Amendments to the Drawings:

Serial No. 10/723,701
Art Unit: 2829
Page 9

REMARKS

Figure 1

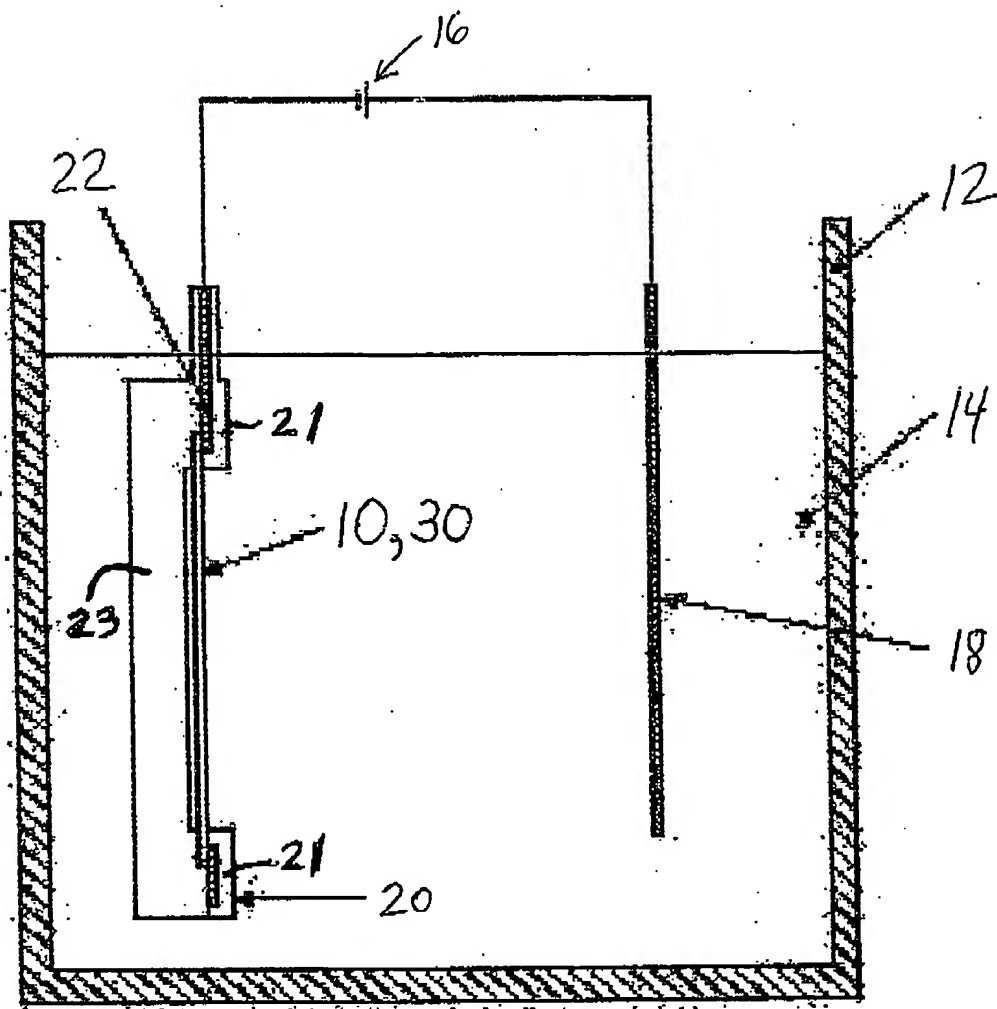
In Figure 1, please reference numerals "21" and "23" and associated lead lines;

Figure 1 and the specification have been amended to clarify that the contact ring is made up of two portions and one of the portions includes electrical contacts. Figure 2 has been revised to clarify the wafer structure. One having ordinary skill in the art would have readily known that the original Figure 2 was in error because the circuit 38 cannot be provided as being floating off the substrate, and one having ordinary skill in the art readily knows that a wafer is continuous. Figure 4b has been amended to clarify what portion of the contact ring is being depicted.

Figure 2

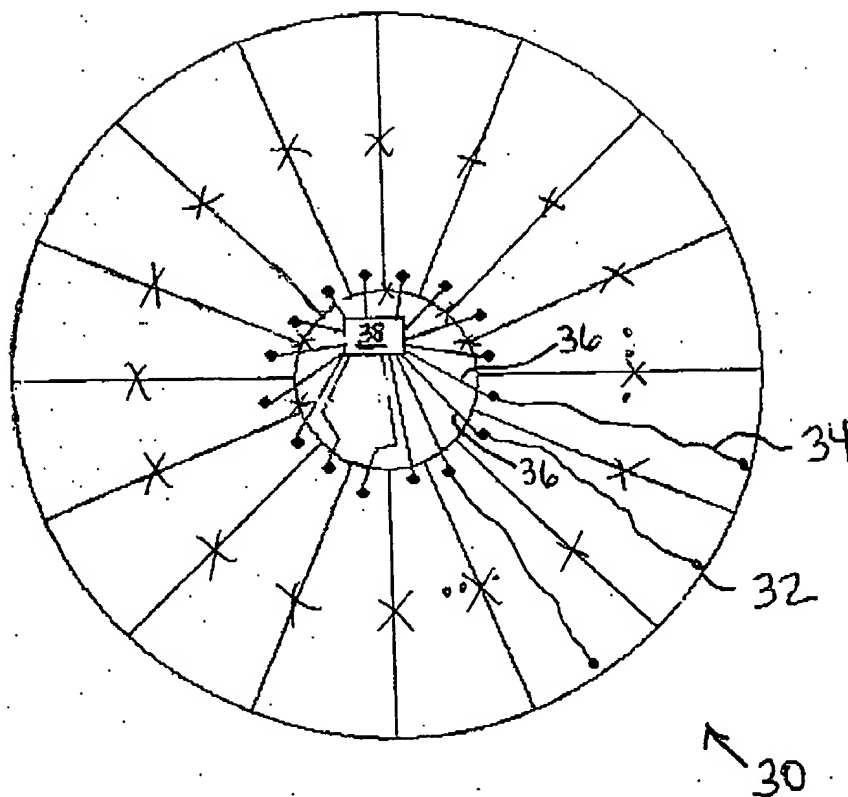
In Figure 2, please redraw as shown on the enclosed sheet; and

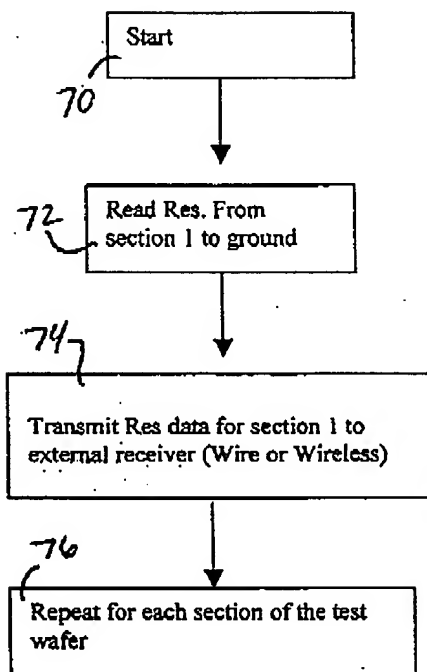
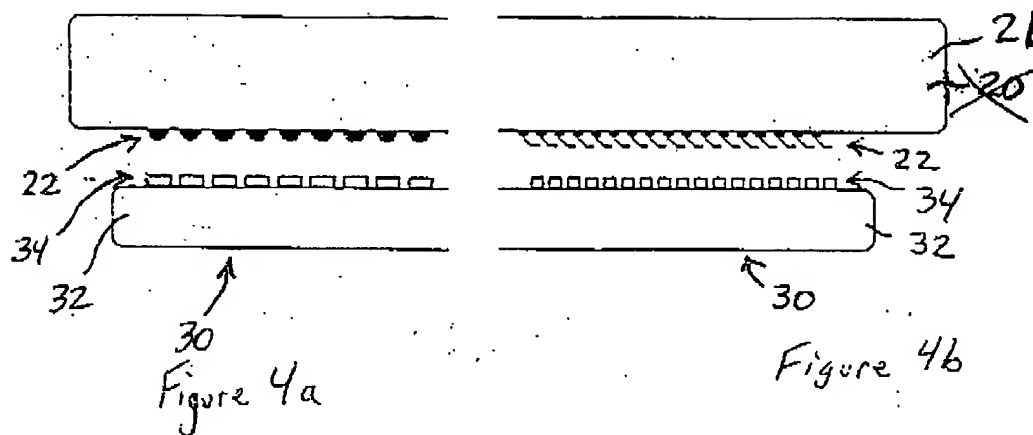
In Figure 4b, please replace reference numeral "20" with reference numeral "21".
